Re: Professional Engineer's Certification of Permanent Control Measure
Flying Horse North Filing No. 4, Pond B

This letter serves as a Pond Certification for the constructed Full Spectrum Detention Facility "Pond B" located in Flying Horse North Filing No. 4. The permanent control measure is located at the north central area of the subdivision and the northwestern part of the filing, adjacent and north of Old Stagecoach Road.

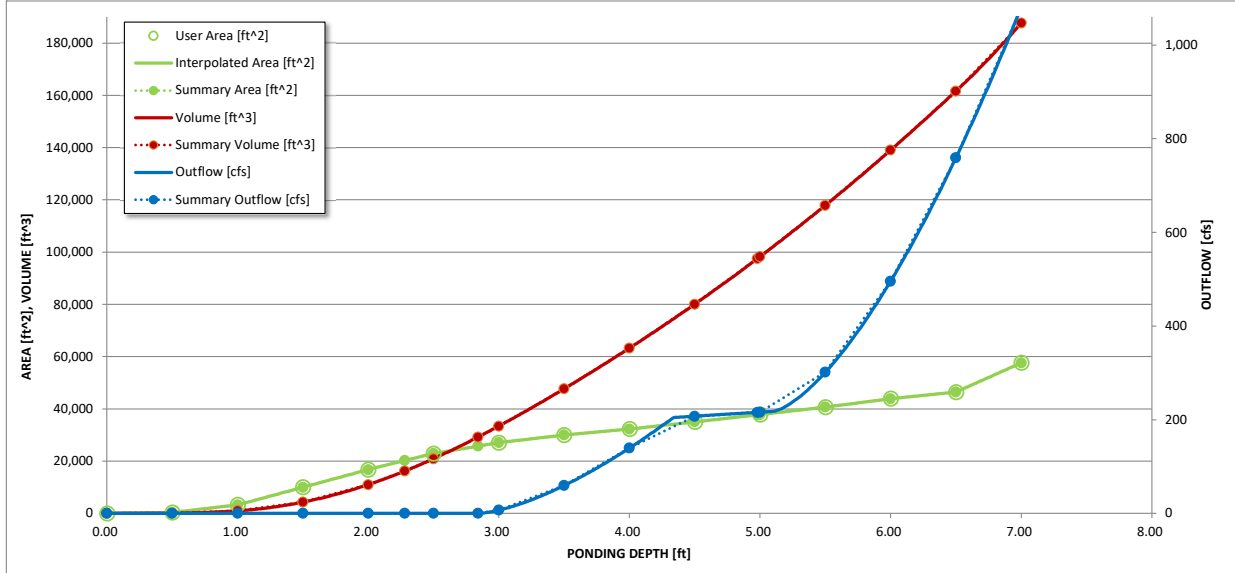
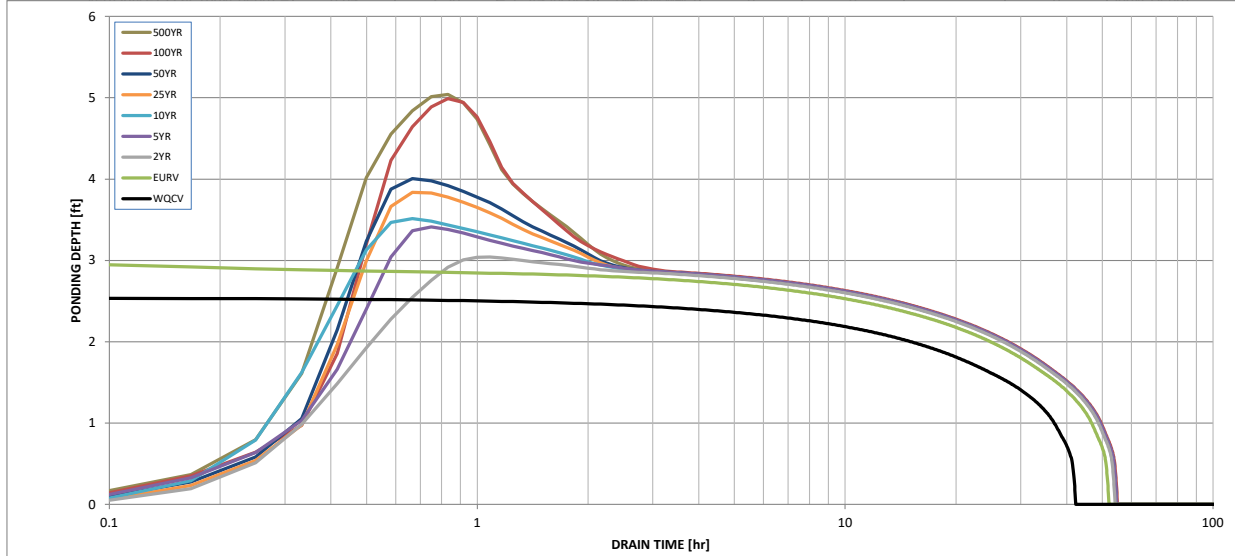
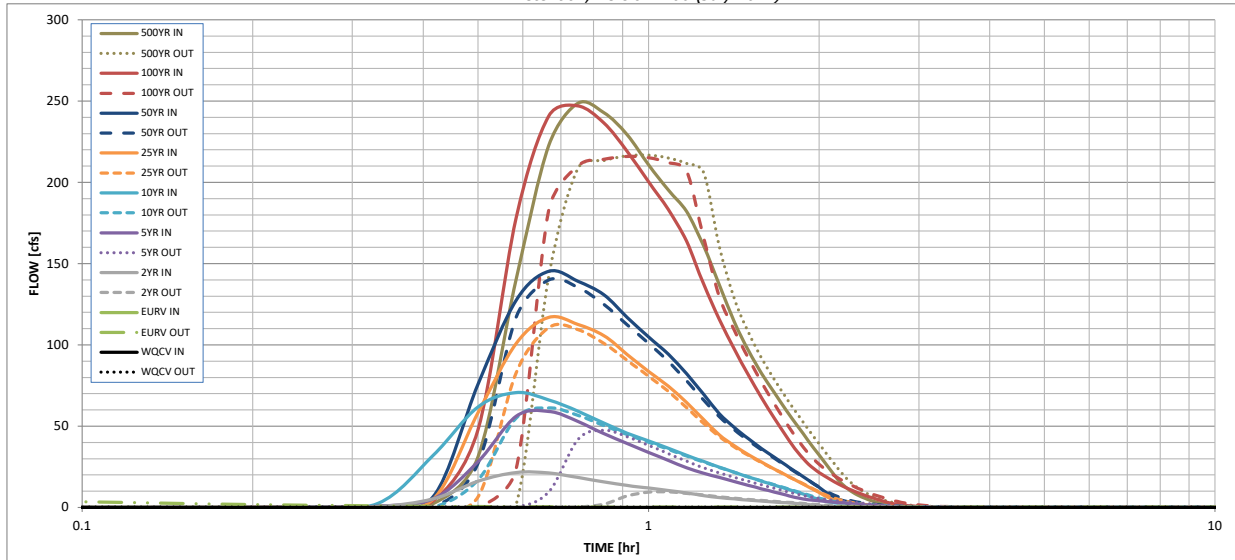
Note to self: I will need to check the output table above again once the Vertical Orifice discrepancy is taken care of.
